VEPCO NOMAD CODE AND MODEL SUPPLEMENTAL INFORMATION.

Docket # 50-280
Control # 8407170305
Date 7/6/84 of Document:
REGULATORY DOCKET FILE

RESPONSE TO QUESTIONS AND COMMENTS ON VEPCO NOMAD CODE AND MODEL (VEP-NFE-1)

FIGURE 9.1

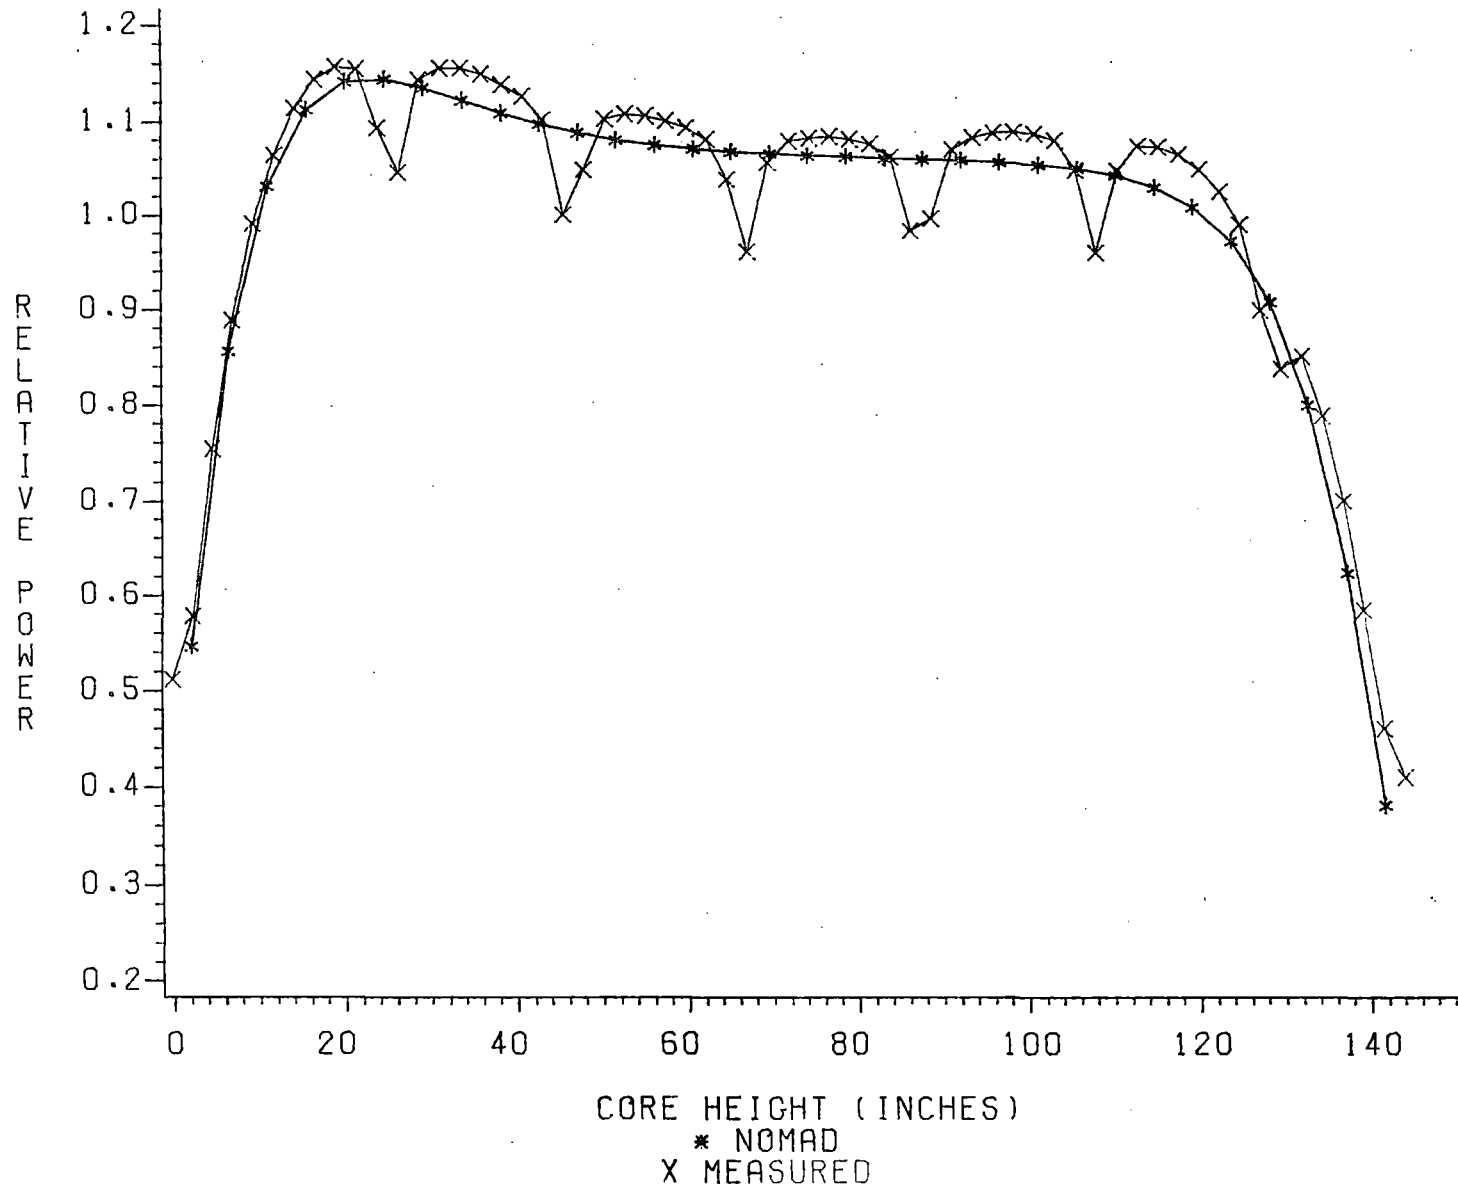
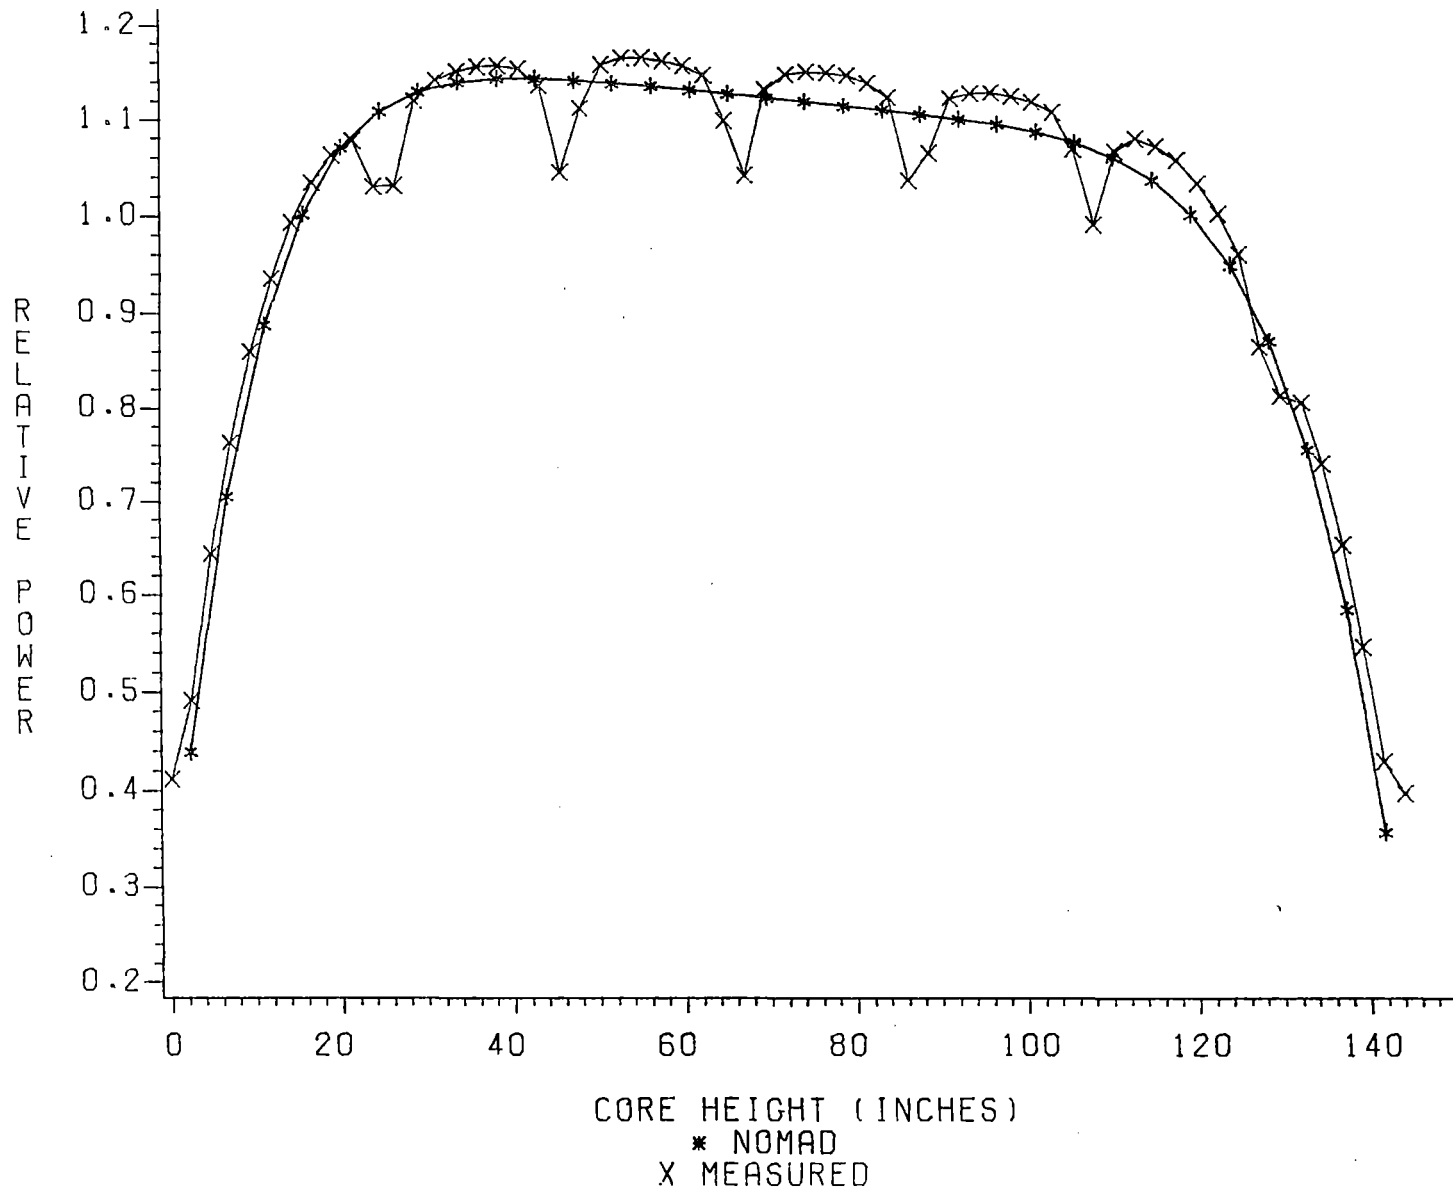
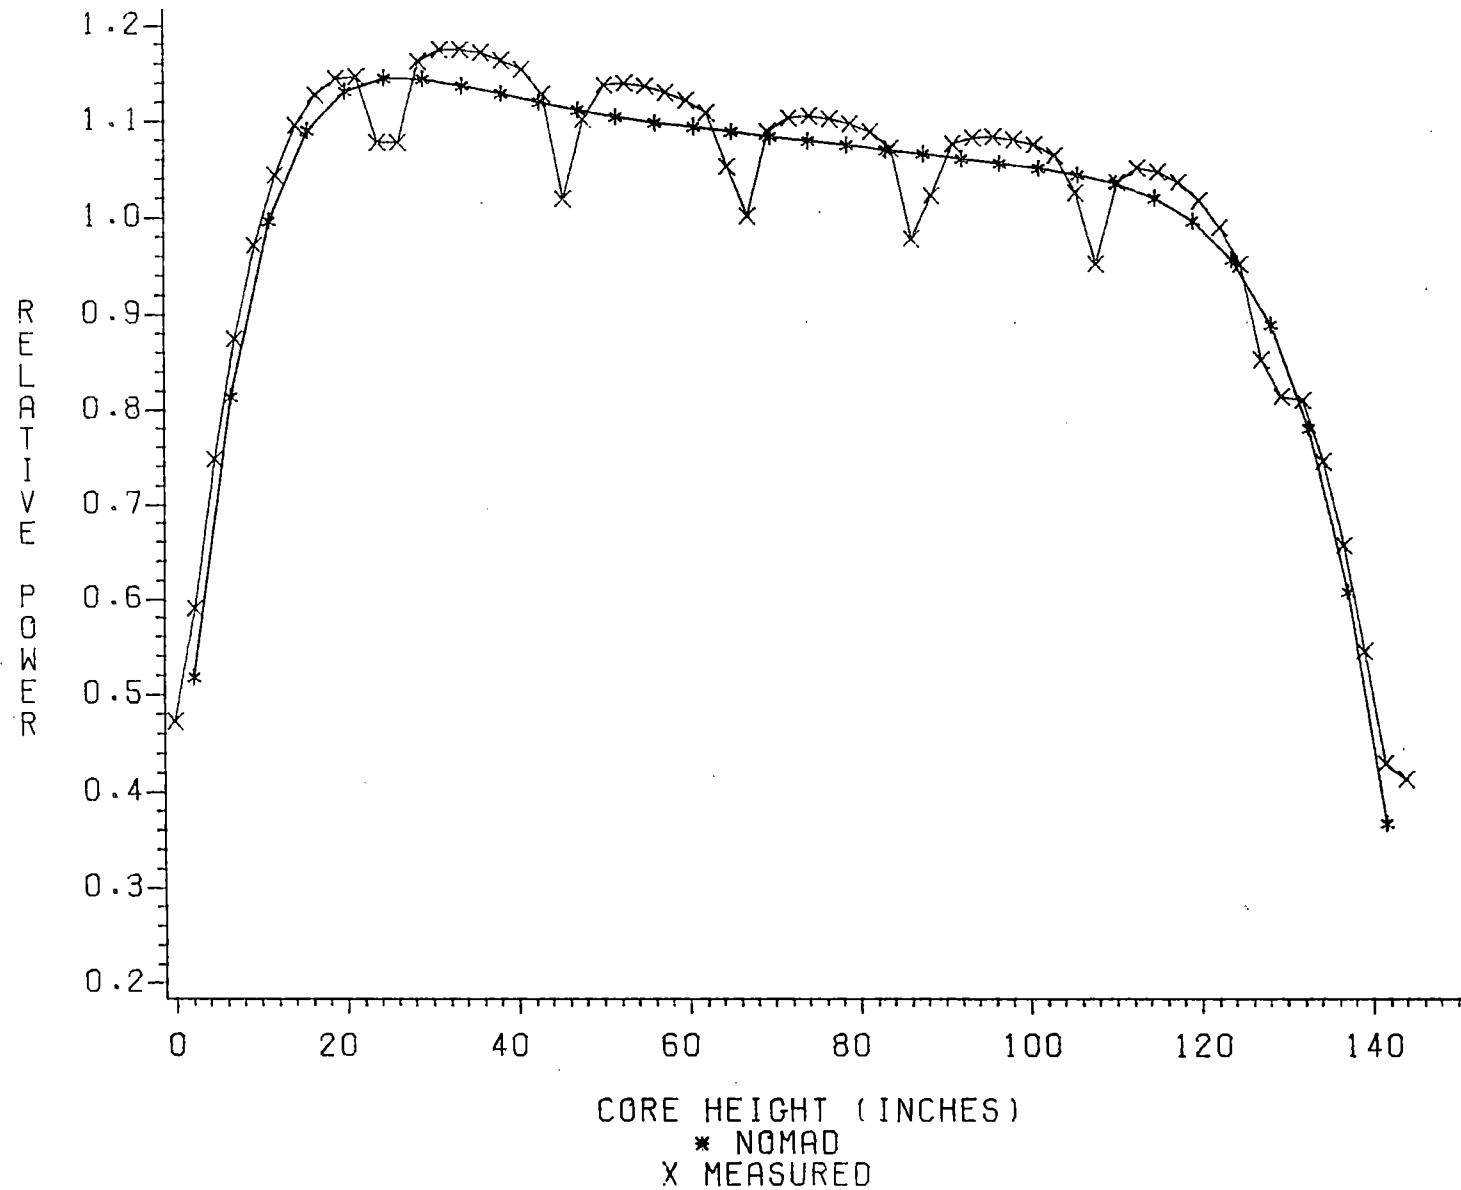
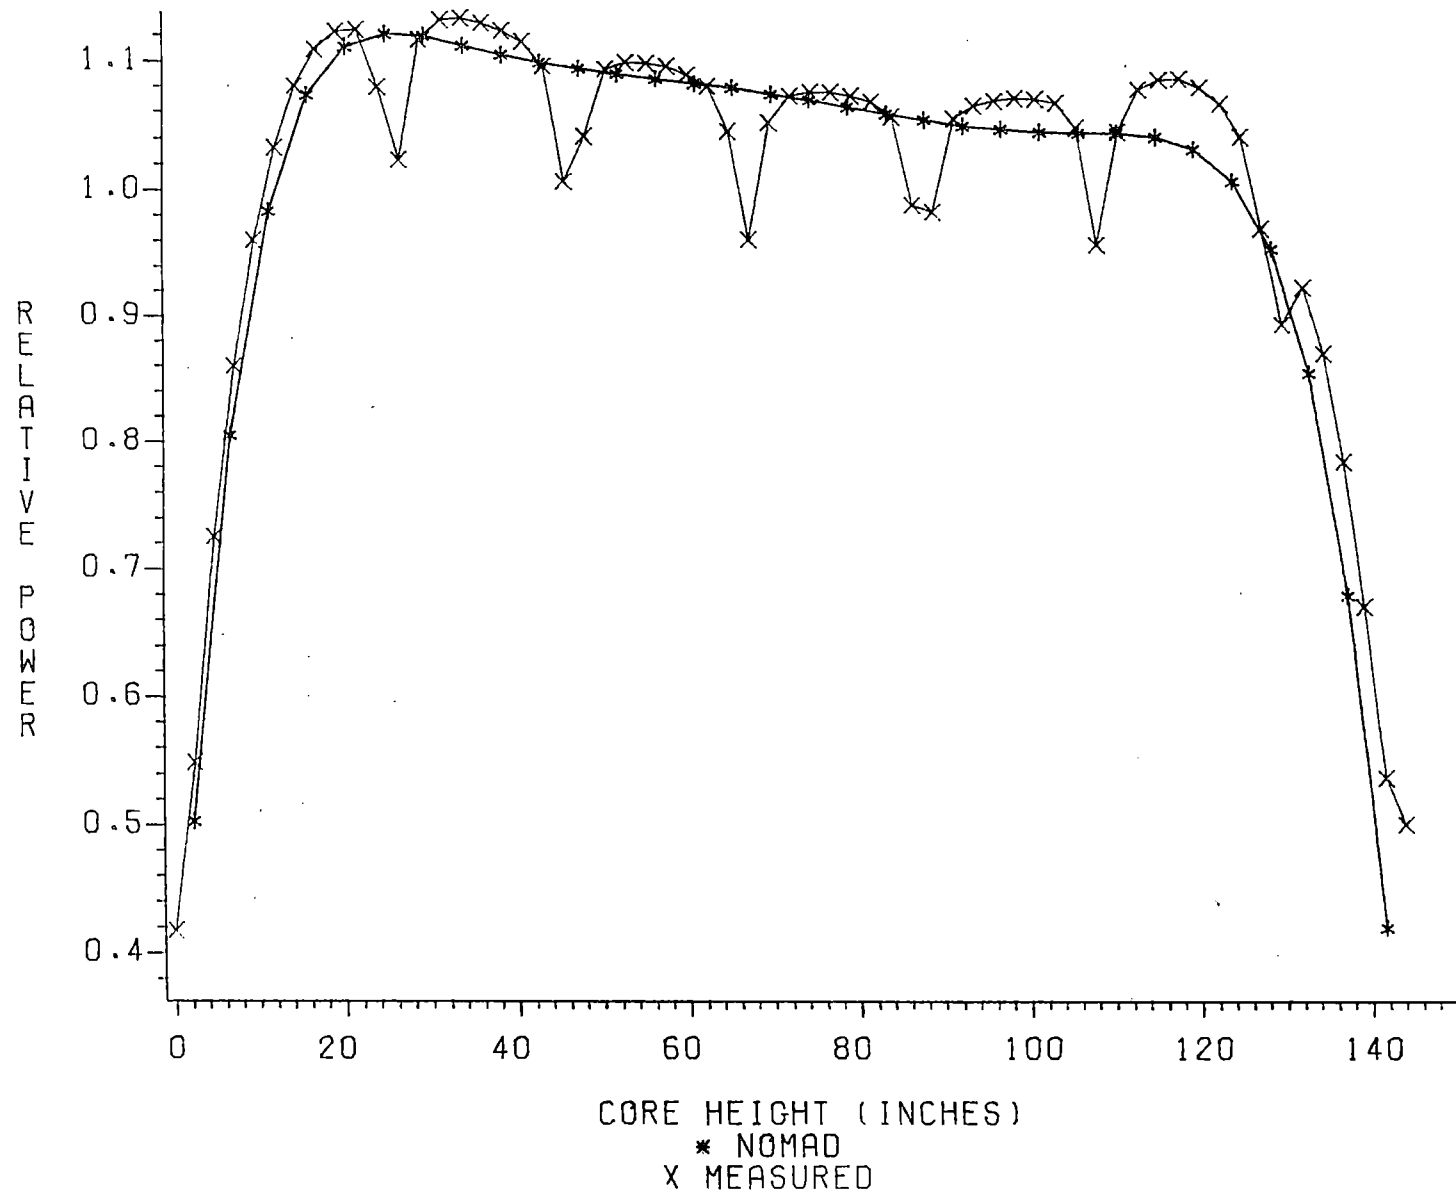
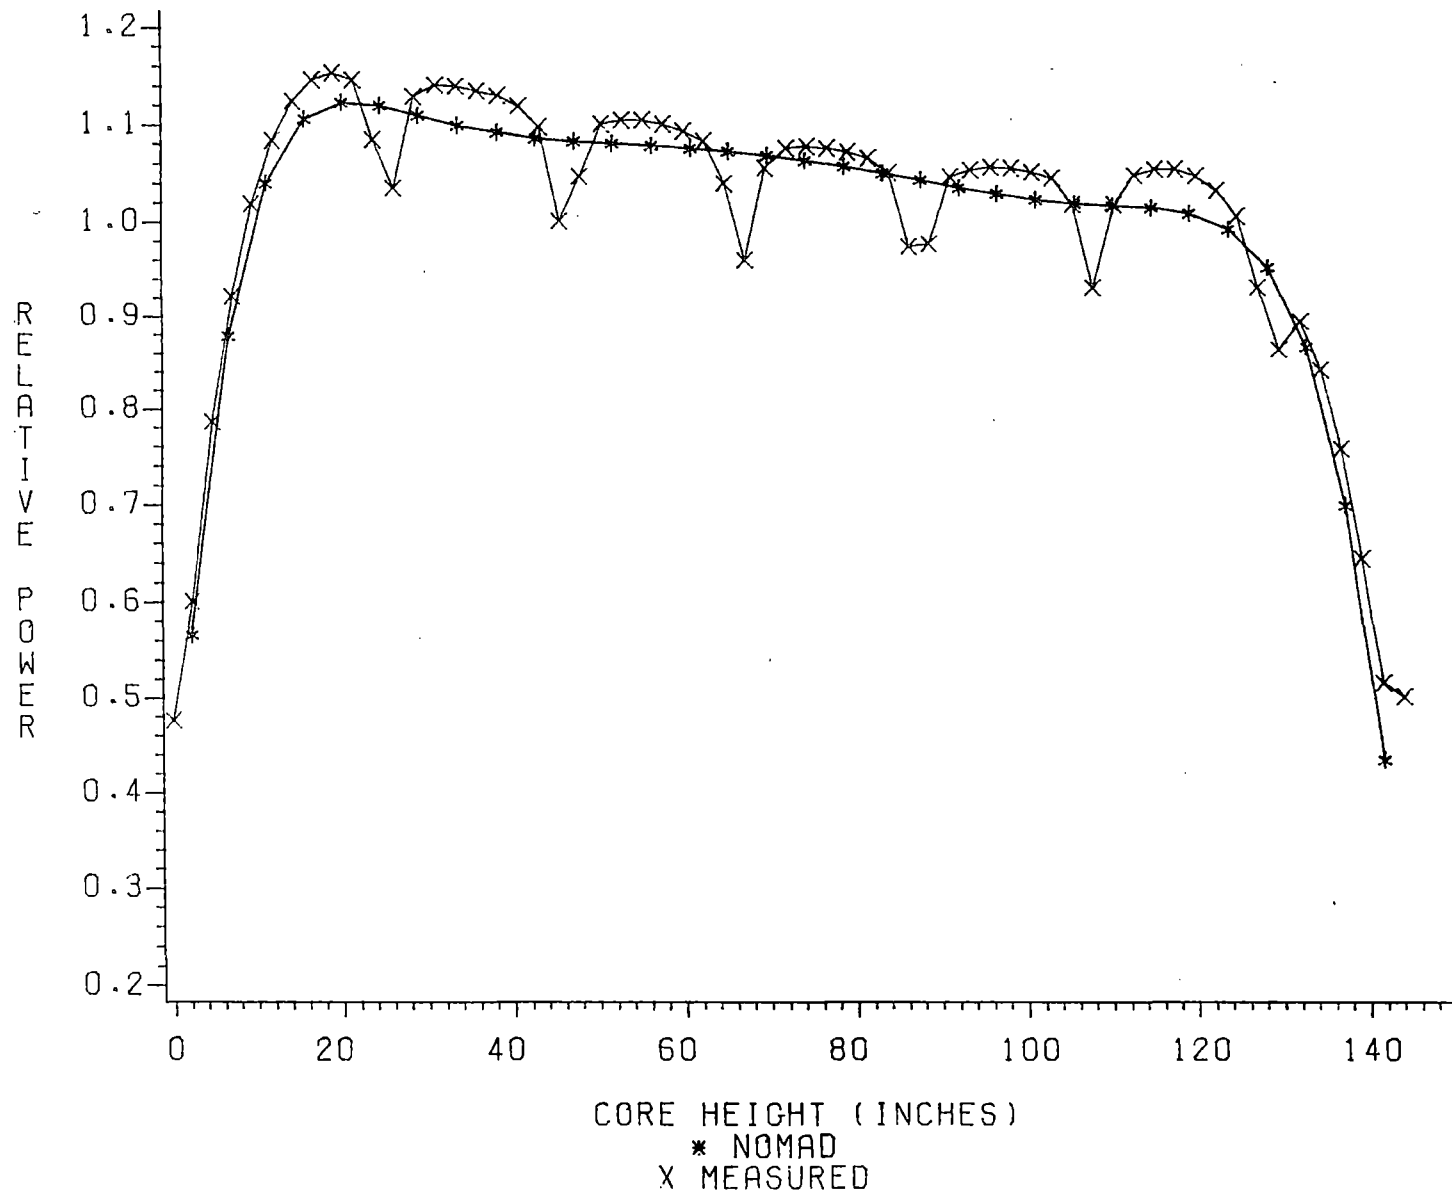
Question 9. Since the NOMAD model incorporates a depletion calculation, comparisons of predicted and measured axial power distributions as a function of burnup should be presented to validate the depletion model. For example, how do EOC axial power distributions compare with measurement?

Figures 9.1 through 9.5 compare NOMAD predicted axial power distributions to INCORE measurements for MOC and EOC for three different cycles. The axial shapes agree very well. Using a 2.5% grid factor is conservative for 94.5% of the points between 15% and 85% of core height for these shapes.
